APPLICATION NO.	FILING DATE	FIRST NAMED INVENTOR	ATTORNEY DOCKET NO.	CONFIRMATION NO.
10/018,625	03/07/2002	Marcel Aeschlimann	FRR-12806	5185
40854	7590	05/19/2004	EXAMINER	
RANKIN, HILL, PORTER & CLARK LLP 4080 ERIE STREET WILLOUGHBY, OH 44094-7836			GARCIA, ERNESTO	
			ART UNIT	PAPER NUMBER
			3679	
DATE MAILED: 05/19/2004

Office Action Summary

DETAILED ACTION

FIG 7

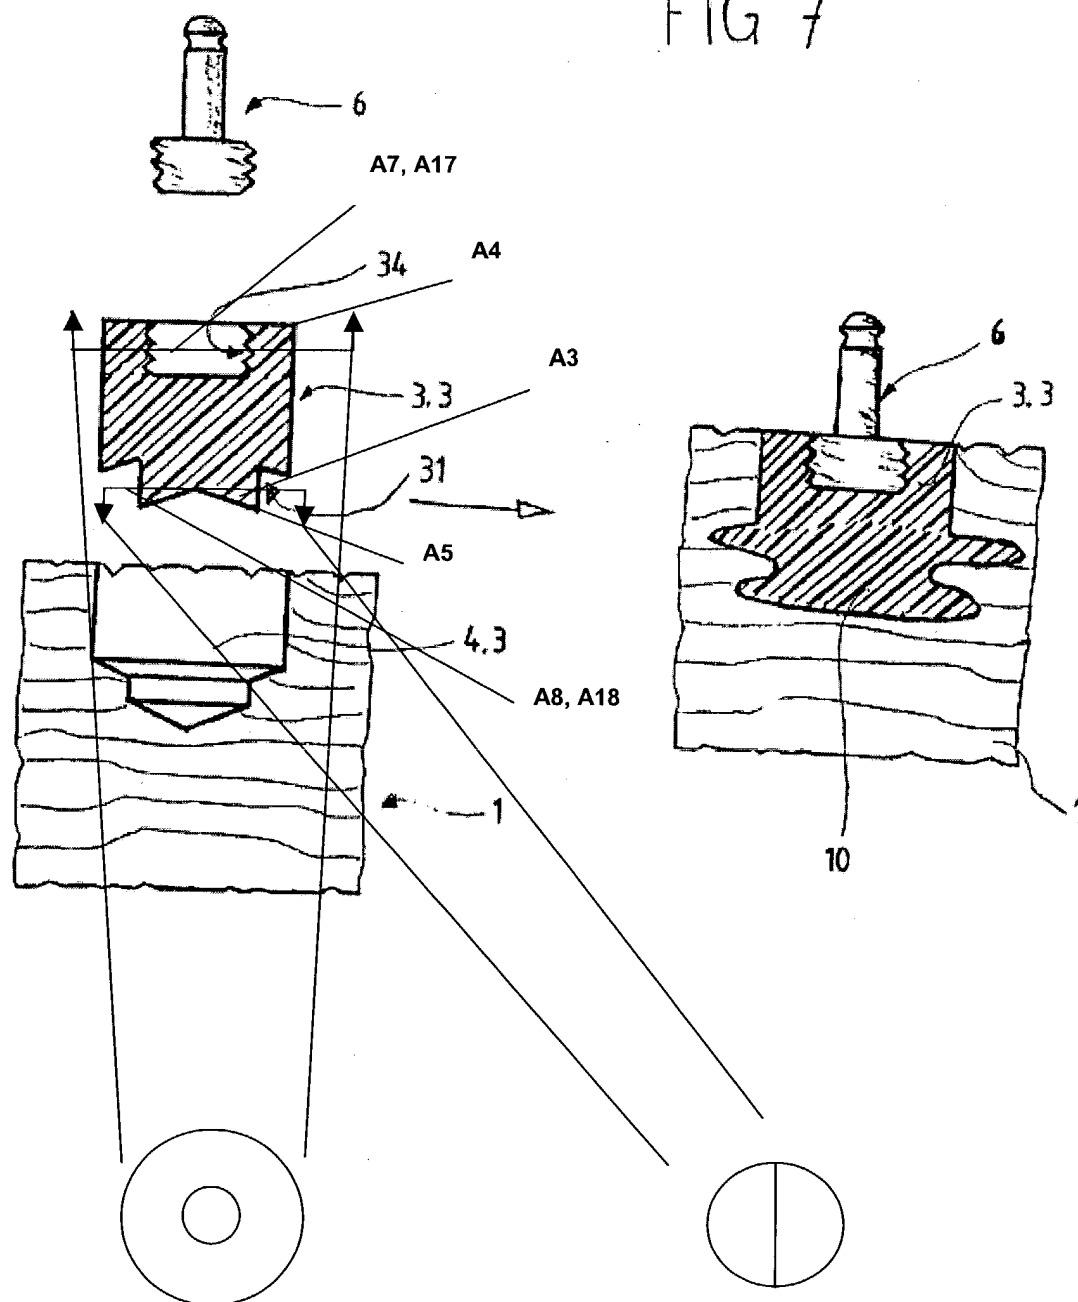
Regarding claim 27, Aeschlimann et al. disclose, in Figure 7, a combination of a joining element **3.3** and a body **1**. The body **1** comprises a porous material (see English Abstract). The joining element **3.3** comprises a first end portion **A3** and a second end portion **A4**. The first end portion **A3** comprises a thermoplastic material and the first end portion **A3** includes a pointed end **A5** or a cutting edge **A5**. Applicant is reminded that the method of forming the combination is not germane to the issue of patentability of the device itself. Therefore, this limitation has been given limited patentable weight. See MPEP ' 2113.

Regarding claim 28, the joining element **3.3** is pin-shaped and has at least two areas **A7,A17** with different cross-sections **A8,A18**.

Regarding claim 29, one of the cross-sections **A8,A18** is round or polygonal.
